2 Falkland Place

Daylight and Sunlight Addendum

Issued: March, 2017

- 1.1 This report is an addendum to the Daylight and Sunlight Assessment report, issued to accompany the planning application for the extension of 2 Falkland Place, London NW5.

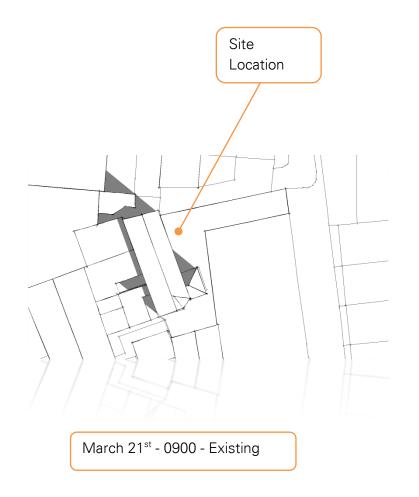
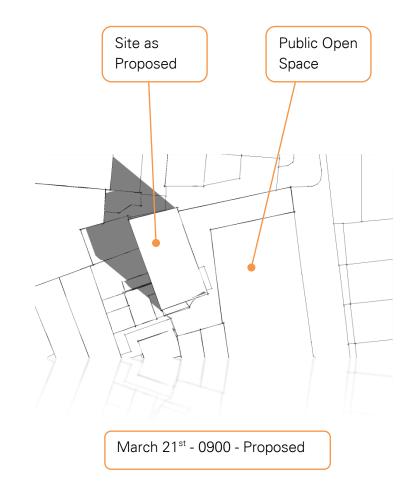
- 3.2 The photographs below show the position of the proposal site in relation to the open spaces (north up). It is quite clear that the proposal site is to the North and North West of these spaces (and also some distance away) and therefore there will be very minimal consequential loss of sunlight provision to these spaces.

- 3.3 The only area which would have a small degree of overshadowing is the far corner of the empty open space to the east (shown in the photo below and in the shadow study at Appendix 1). It remains our conclusion that these effects are acceptable in line with BRE guidance.
